# ADDENDUM

Date:	March 9, 2020
Project:	Mountainstar- Ogden Regional Medical Center <b>Psych Exam Remodel</b> 5475 South 500 East Ogden, Utah 84405
Addendum Number:	<b>1</b>

**PROJECT:** ORMC Psych Exam Remodel

**RE:** Addendum #1

**1 PSYCH EXAM DEMOLITION PLAN**  
SCALE: 1/4" = 1'-0"  
NORTH

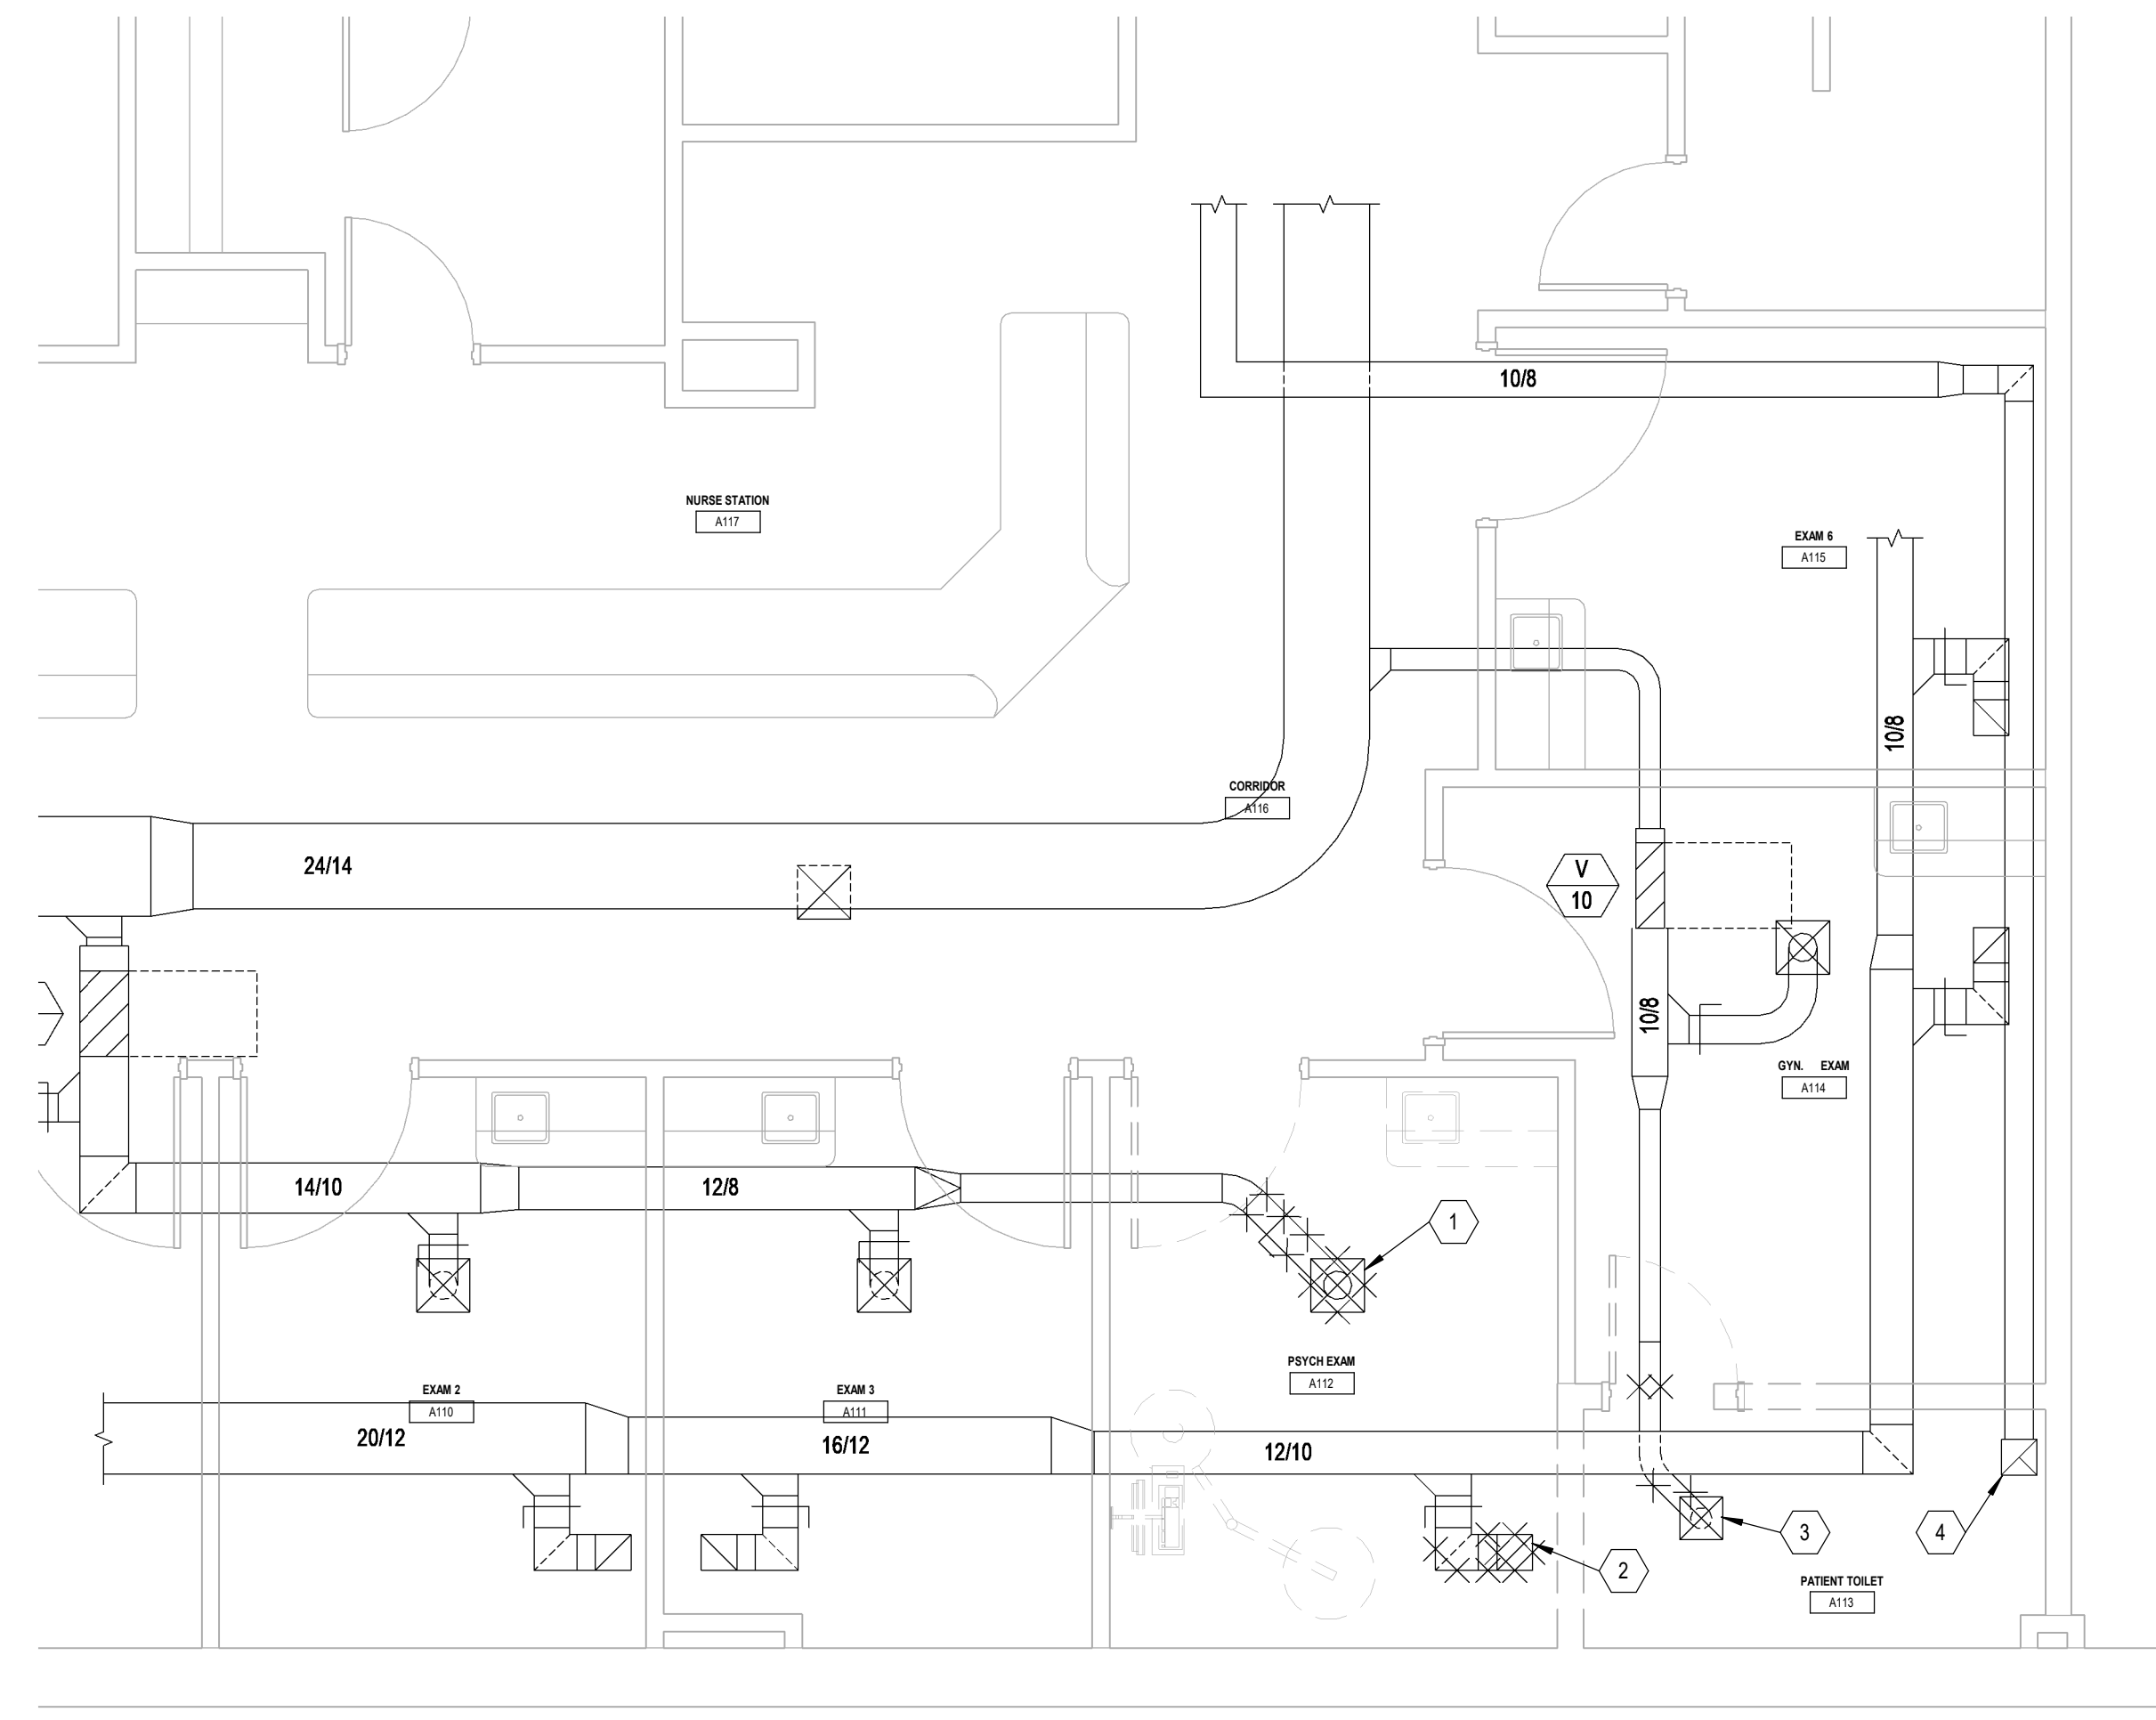
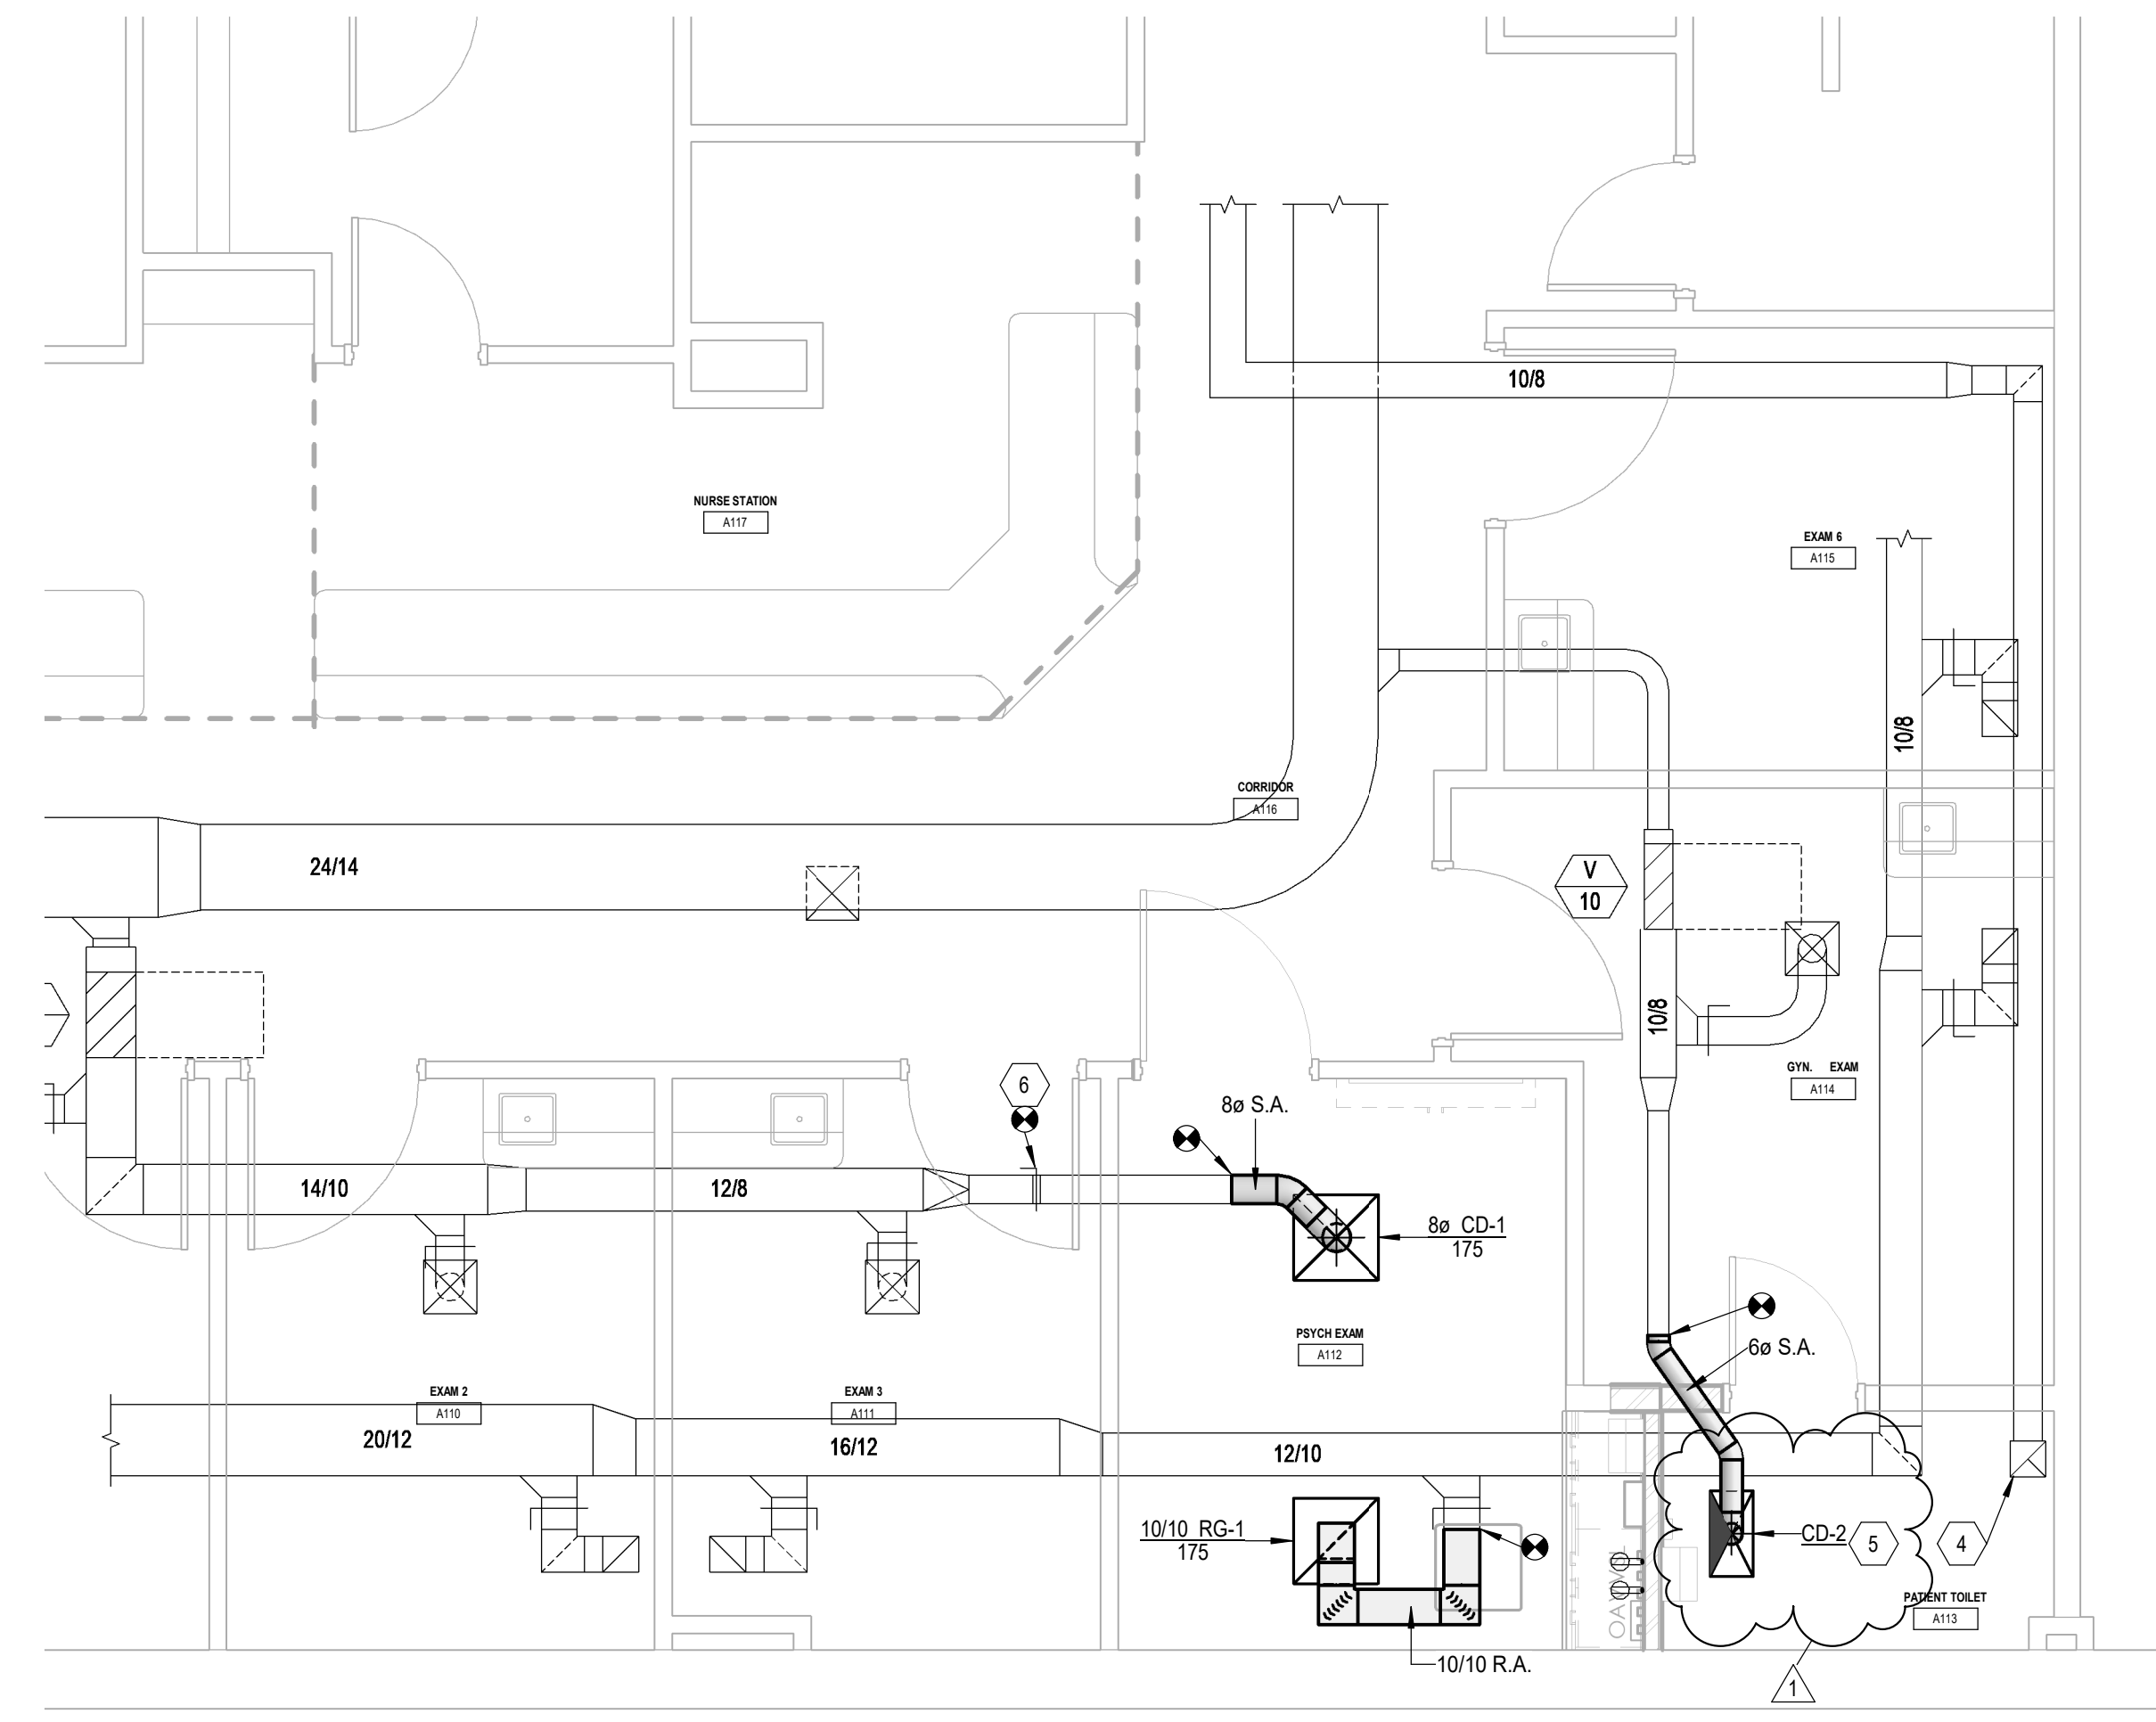
1. Sheet MH102 – Psych Exam Mechanical Plans
  - a. Keyed notes #3 & 5 have been updated to call for the existing 24x24 supply diffuser in Patient Toilet A113 to be removed and replaced with a new 12x24 supply diffuser.

- b. Psych Exam Mechanical Plan - Patient Toilet A113
    - i. The supply diffuser in this room is now called out as a new CD-2 diffuser.
2. Sheet MH202 – Psych Exam Reflected Ceiling Plans

3. THIS EXISTING 24x24 SUPPLY DIFFUSER IS TO BE REMOVED. MEASURE THE MAXIMUM AIRFLOW OF THE EXISTING DIFFUSER PRIOR TO REMOVAL. DEMOLISH THE ASSOCIATED SUPPLY AIR DUCTWORK BACK TO THE APPROXIMATE LOCATION SHOWN.

4. THIS EXISTING EXHAUST AIR GRILLE IS TO REMAIN IN SERVICE. PROTECT FROM DAMAGE.
5. INSTALL THE NEW 12x24 SUPPLY AIR DIFFUSER IN THIS LOCATION. AFTER THE CONSTRUCTION HAS BEEN COMPLETED, REBALANCE THE MAXIMUM AIRFLOW THROUGH THIS NEW DIFFUSER TO THE PREVIOUSLY MEASURED VALUE.
